Response Recommendations of last Machine Advisory Committee

W. Fischer and T. Roser

Electron and pressure rise

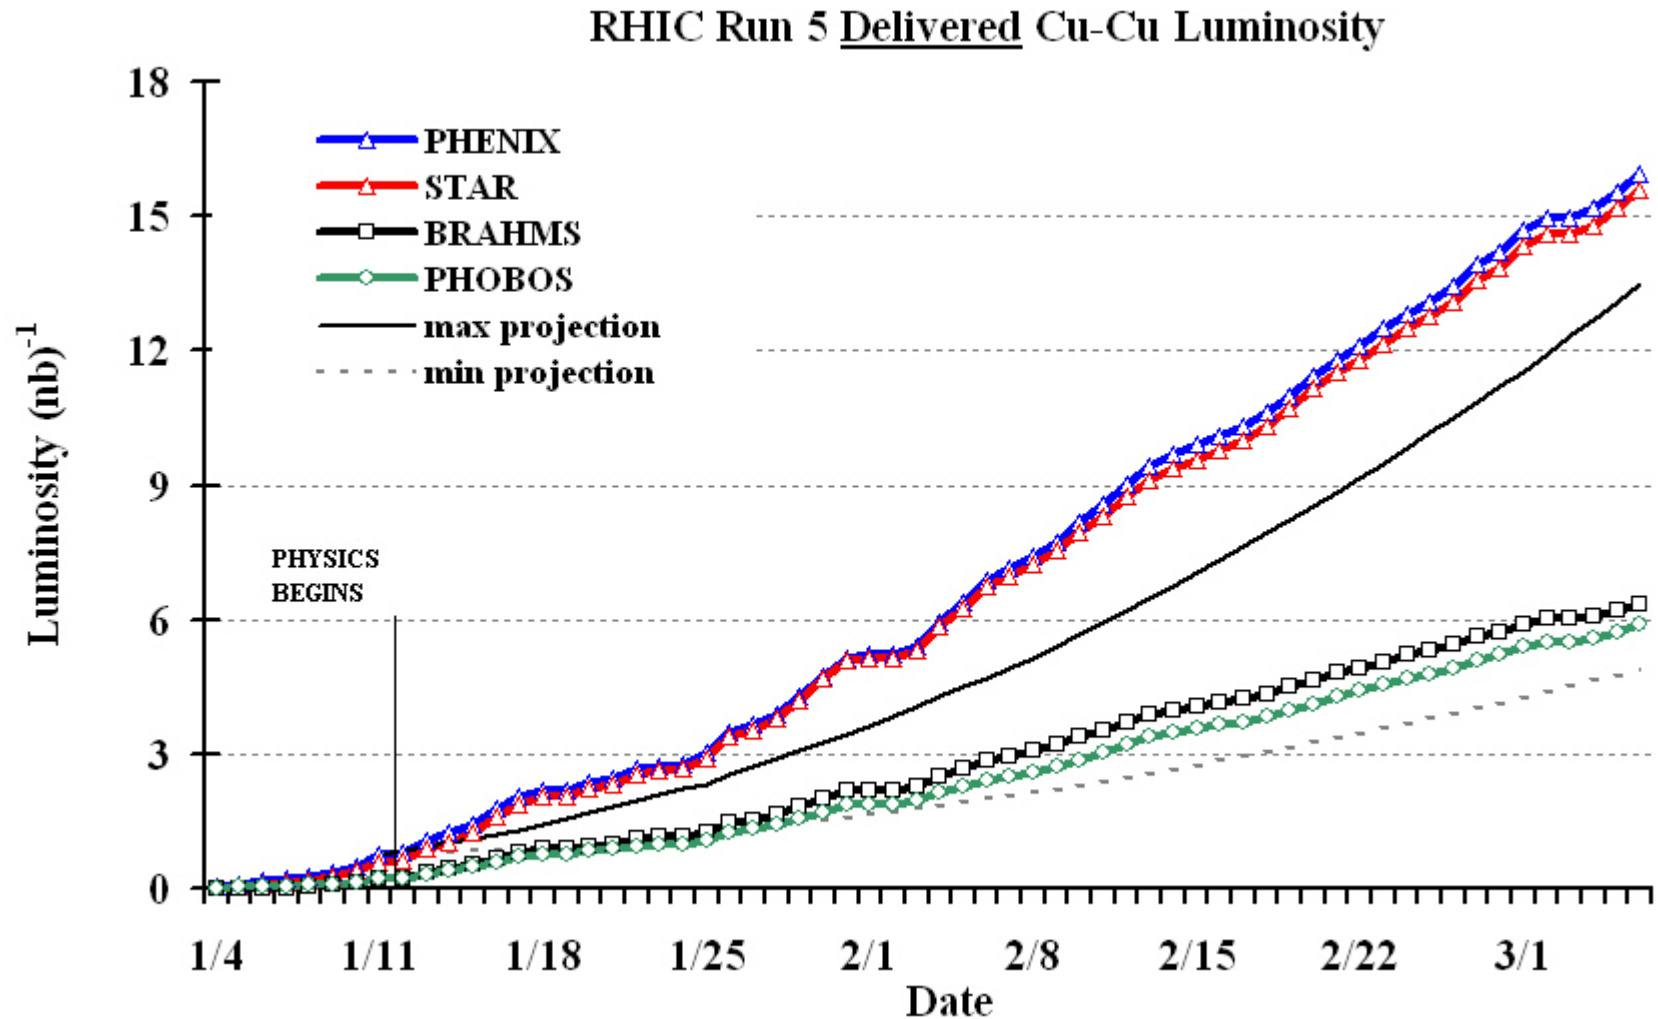
“The committee therefore recommends pursuing the quest of ECI in luminosity operation and attempting to clarify this issue. The committee can see possible way of making further progress with this issue by measuring the coherent tune shift across the bunch train or additional effort to observe the electrons directly in the beam pipe. “

- Electron clouds were observed directly at store
- Final luminosity in Cu-Cu operation reached value predicted from vacuum limitations due to electron clouds

**Clear connection
between e-cloud
and pressure
throughout ramp**
(Interaction Region 12)

Stochastic cooling

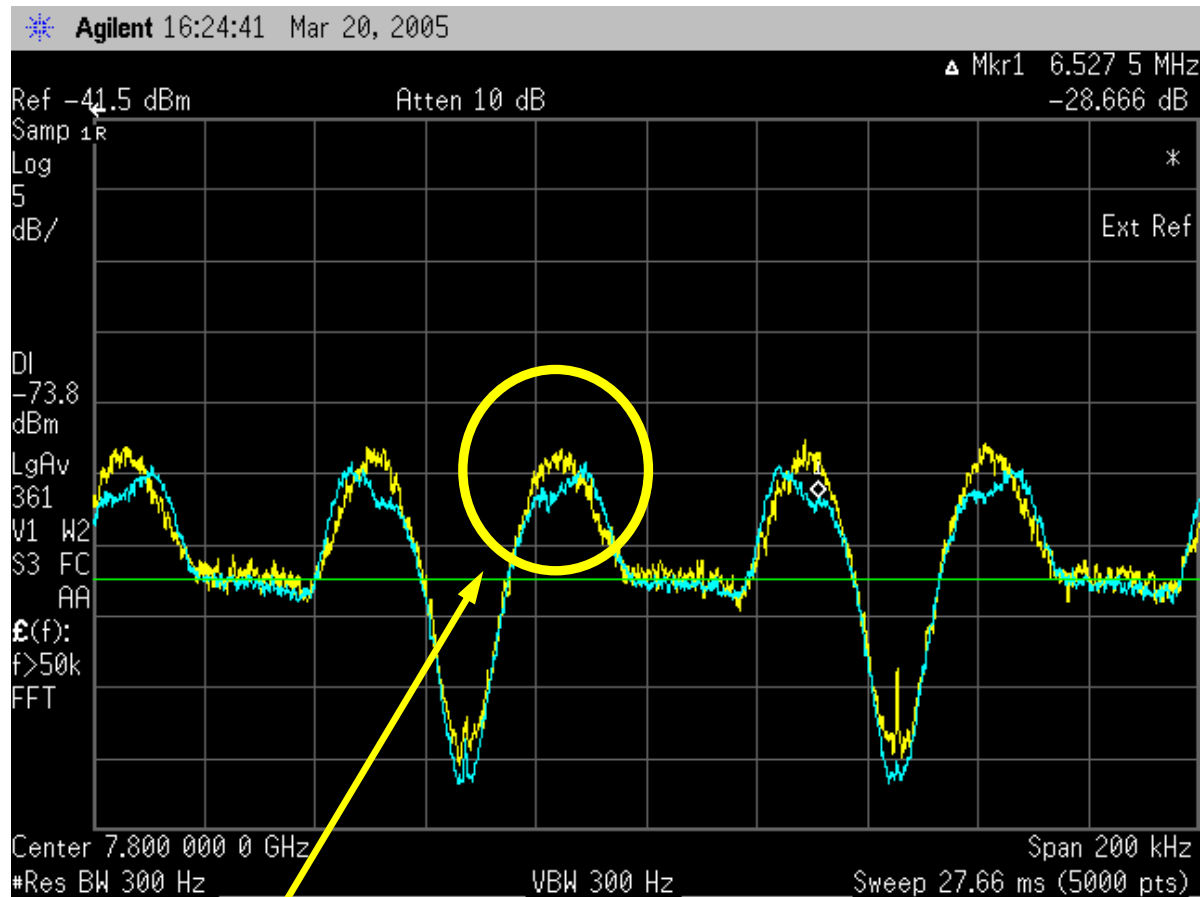
“The committee therefore suggests investigating the possible benefit of a signal connection across the accelerator ring (“cutting a cord”) which would provide more margins in the achievable cooling rates and in addition would open the possibility to increase the bandwidth to 16GHz, which might be feasible.”

→ Has not been quantified yet.

Signal suppression with Cu^{28+} ions
no cooling yet
